MECKLENBURG COUNTY HEALTH DEPARTMENT

APPLICATION FOR PERCOLATION TEST

SOIL INVESTIGATION REPORT

SITE INVESTIGATION REPORT
INDIVIDUAL SEPTIC TANK SYSTEM
WITH SUBSURFACE,
SOIL ABSORPTION,
EFFLUENT DISCHARGE

DIAGRAM OF PROPERTY

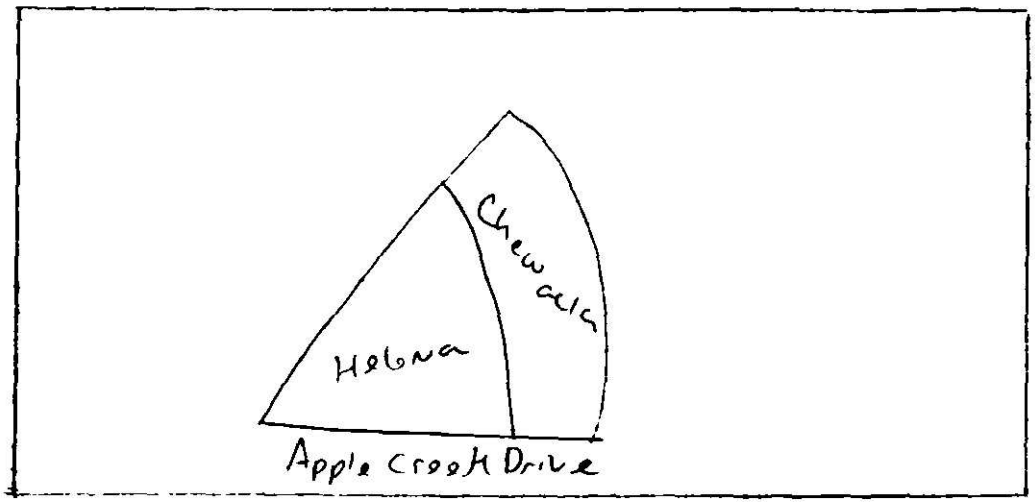
Soil Properties	Soil 1	Soil 2	Soil 3	Soil 4
1. Soil Series	Helvetia		Chehalis	
2. Soil Slope	suitable 2-6%		—	
3. Soil Depth	unsuitable <46"		—	
4. Soil Texture	unsuitable 2.1 clay S		—	
5. Soil Structure	unsuitable massive		—	
6. Restrictive Horizons	—		—	
7. Soil Drainage	unsuitable perched high water table		unsuitable poorly drained	
8. Soil Permeability (Percolation Rate)	unsuitable very slow >200 min/in.		unsuitable seasonal	high water table < 18" from surface
9. Other	—		unsuitable floods	
10. Overall Rating	unsuitable		unsuitable

Recommendations Based on this investigation, the lot was found to have soils dominantly unsuitable for installation of a septic tank system.

See diagram on back
